Memorandum

SUBMISSIONS 530 & 567 - ANDRE GALVIN & VICTORIA YORKE, HARURU

Figure 2 My revised recommendation for reduction of the HNCs 409 and 422

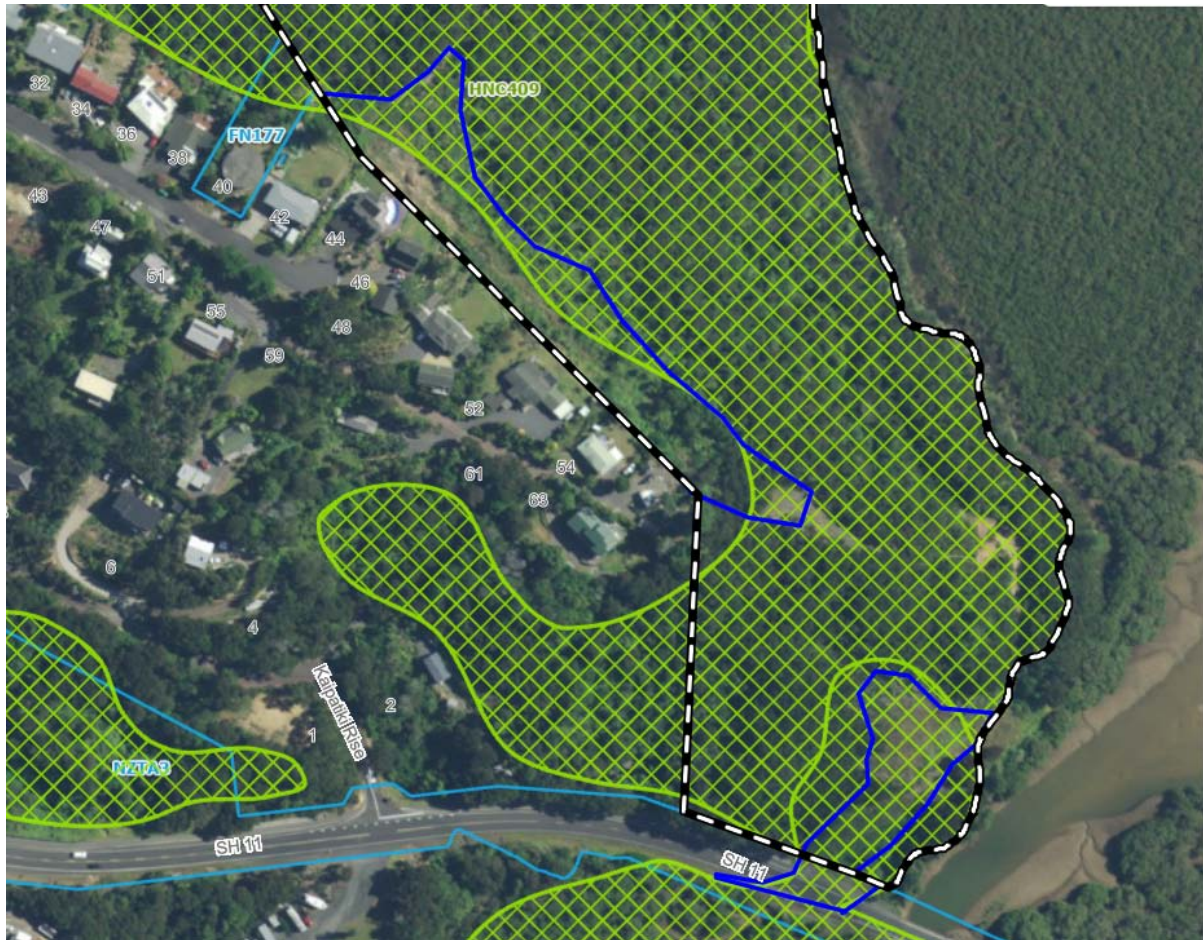
HNC 409, as shown above, does not extend up to the boundary of the submitters' property (marked by the black and white line) on the western boundary. Nevertheless, I believe the HNC overlay could be moved back further from that boundary, as shown by the blue line in **Figure 2** above.

I had already recommended a reduction in the extent of HNC 422 (to the south of HNC 409) as shown in **Figure 1** above. **Figure 2** shows a minor amendment to that recommendation which better follows the line of the current edge of the vegetation and also removes the small stub of the overlay where it crosses SH11.

Figure 2 above illustrates the extent of reduction of the two HNC overlays that I find appropriate. Mr Brown's Area 1 extends further from the south-western boundary of the property than I think appropriate. While it is difficult to identify the precise edge of the disturbed and weed-filled area from aerial photography, I think Mr Brown's line goes beyond that edge to varying degrees along this boundary.
